CITY OF KIRKLAND
Planning and Community Development Department
123 Fifth Avenue, Kirkland, WA 98033 425.587.3225
www.kirklandwa.gov

DESIGN REVIEW BOARD DECISION ON DESIGN RESPONSE CONFERENCE APPLICATION

Date: January 24, 2013
File No.: DRV12-00921
Project Name: Lake Street Place
Applicant: Rick Chesmore with Chesmore|Buck Architecture

2 ENLARGED COURTYARD PLAN
1" = 10'

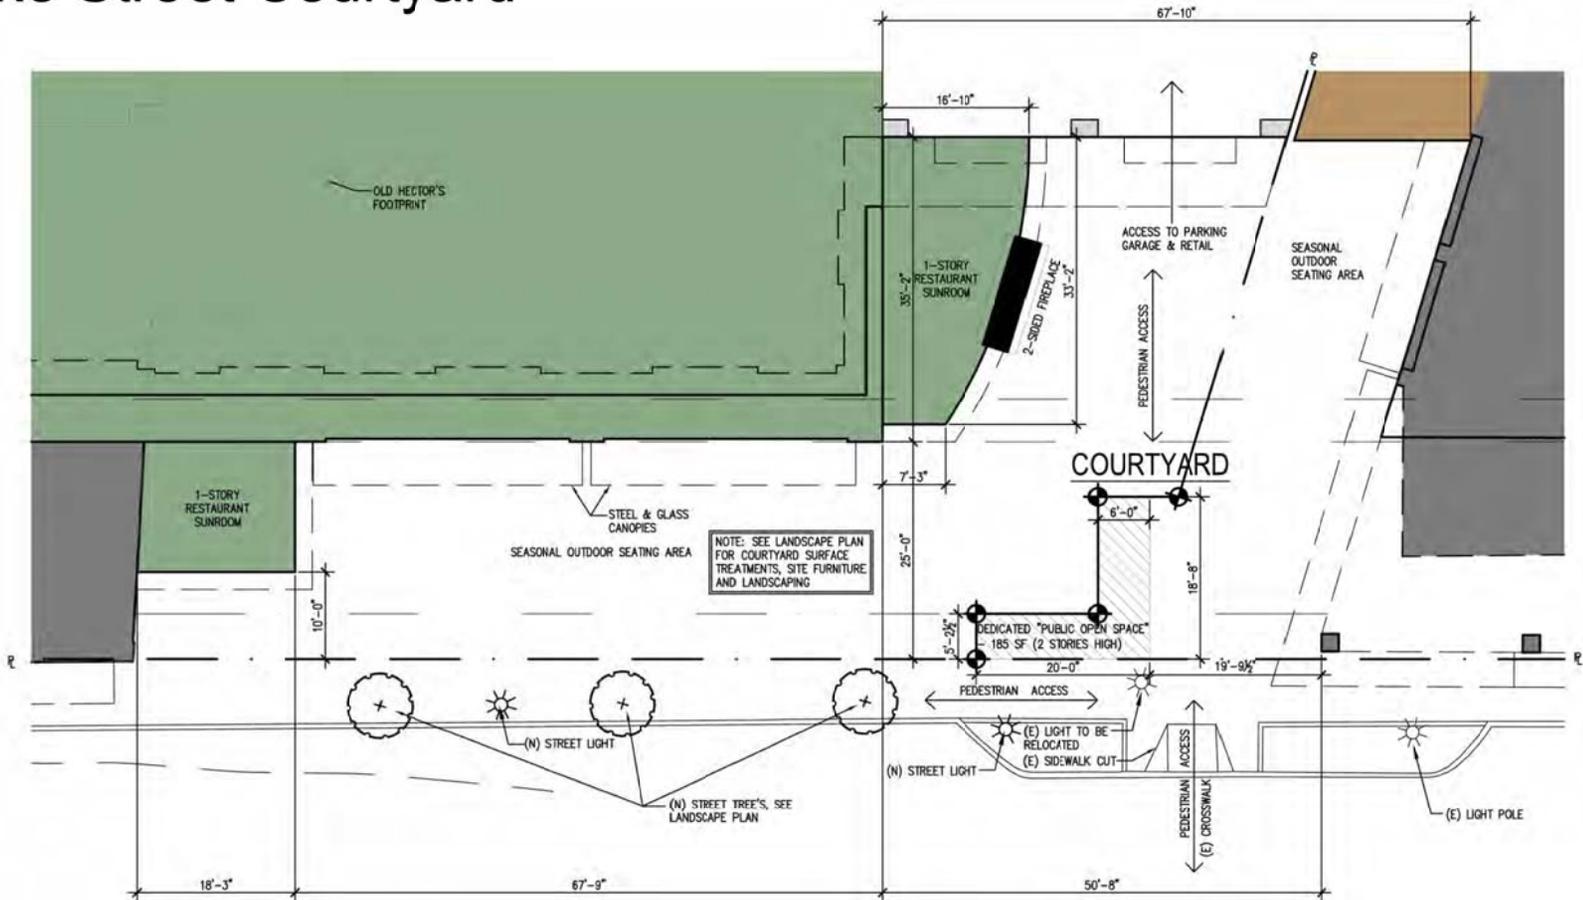
- 7. Detailed courtyard plans that specify that the outdoor seating areas are modular and delineated by moveable planters, seating, and railings.
- C. All furnishings (such as planters, seating, and railings) in the courtyard off Lake Street South shall remain modular and shall not be permanently affixed.

The DRB also concluded that courtyard design meets the design guidelines on the condition that detailed courtyard plans are submitted with the building permit specifying that the outdoor seating areas be delineated by moveable planters, benches, and railings. By maintaining courtyard furnishings that are modular rather than permanently affixed, the space can be adapted for both private and community functions as described by the applicant in their proposal.

1 LANDSCAPE PLAN - COURTYARD & FRONTAGE IMPROVEMENTS
 1/8" = 1'-0"

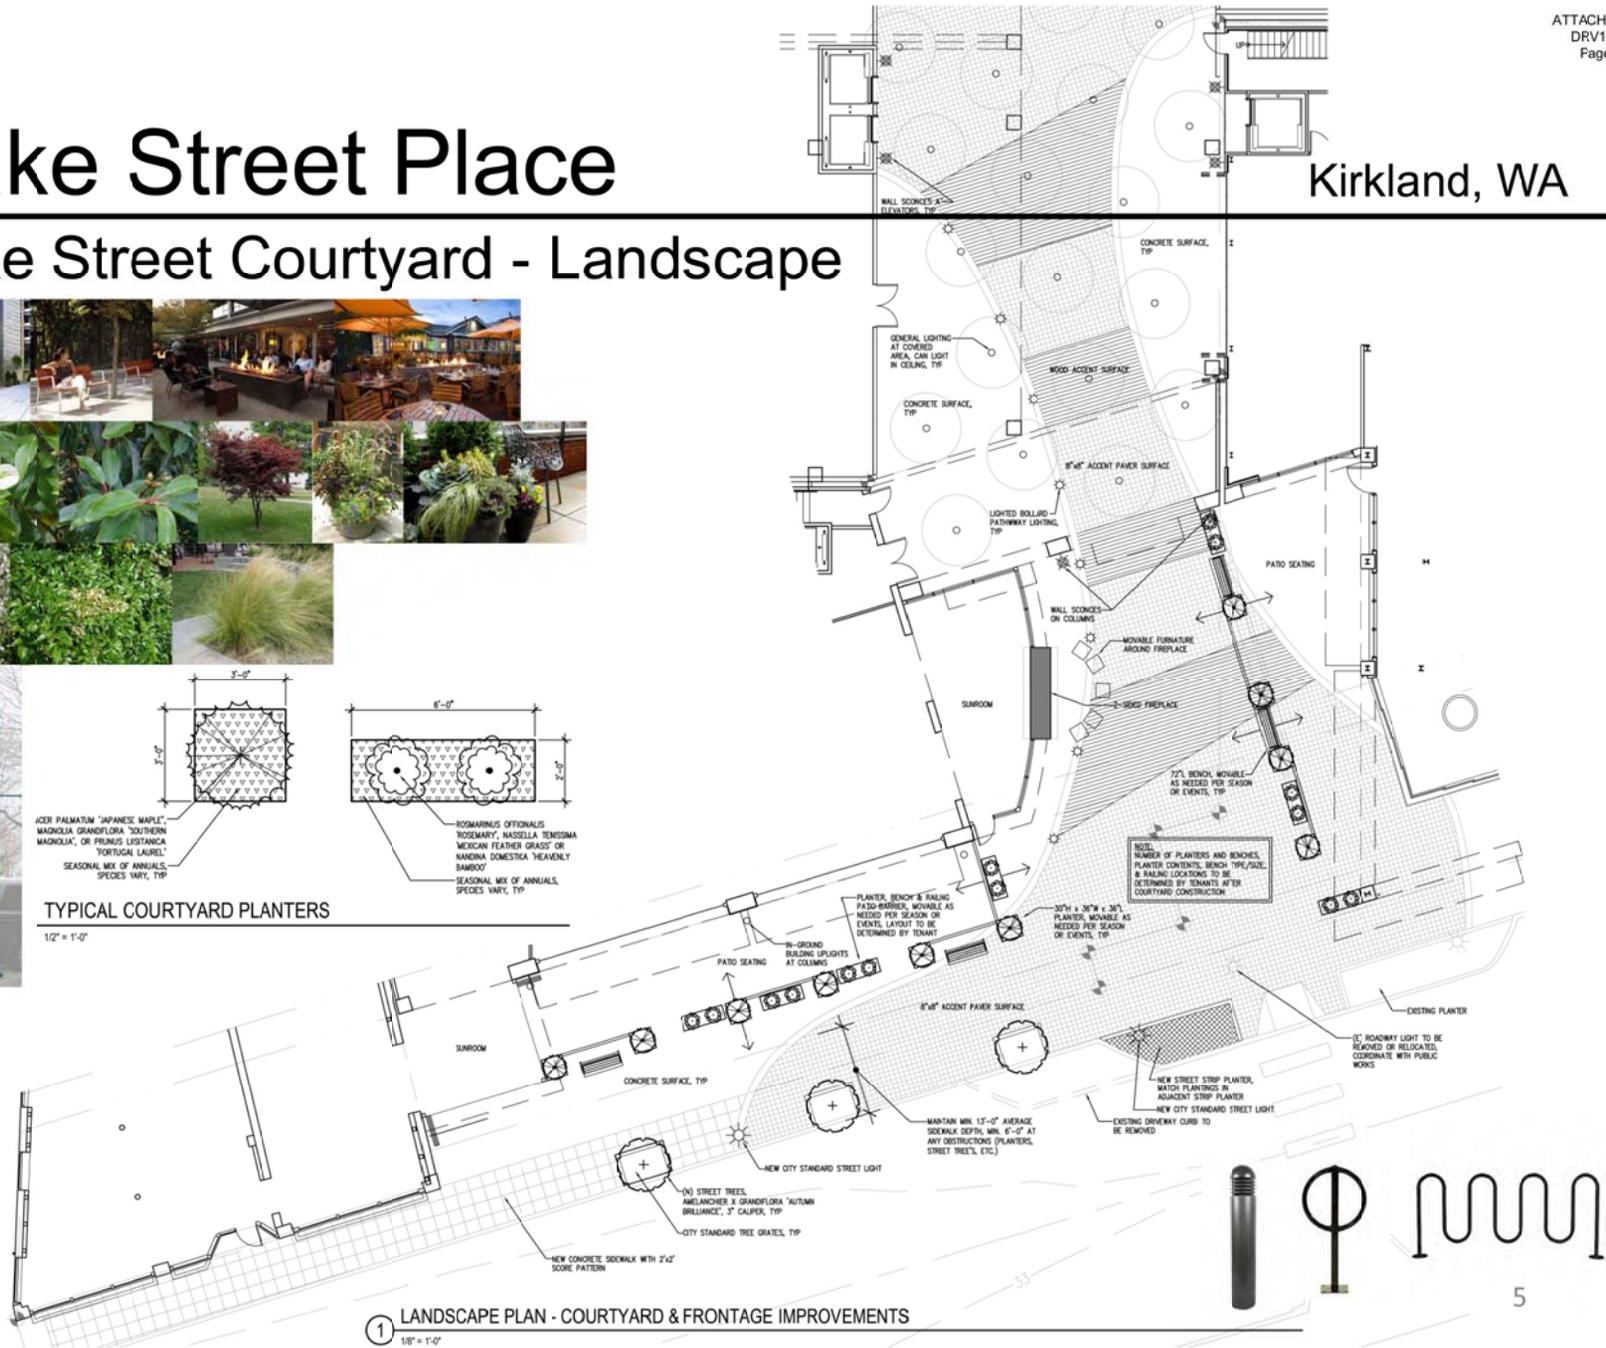
- South façade of the Main Street Building that is consistent with Option 1 (infill horizontal panel siding).
 3. Detailed landscape plans that:
 - Replace the *Salix discolor* (American pussy willow) near the public walkway with a different plant species that is columnar and evergreen.

- Update the plant species to have additional diversity and seasonal interest. The resulting planting plan shall be dynamic with a variety of color and contemporary plant species which expand upon the *Phyllostachys nigra* (black bamboo) aesthetic proposed near the public walkway.

2. Conclusion: The DRB concluded that the proposed landscape plan meets the design guidelines with the following conditions:
 - Replace the Salix discolor (American pussy willow) near the public walkway with a different plant species that is columnar and evergreen.
 - Update the plant species to have additional diversity and seasonal interest. The resulting planting plan shall be dynamic with a variety of color and contemporary plant species which expand upon the Phyllostachys nigra (black bamboo) aesthetic proposed near the public walkway.
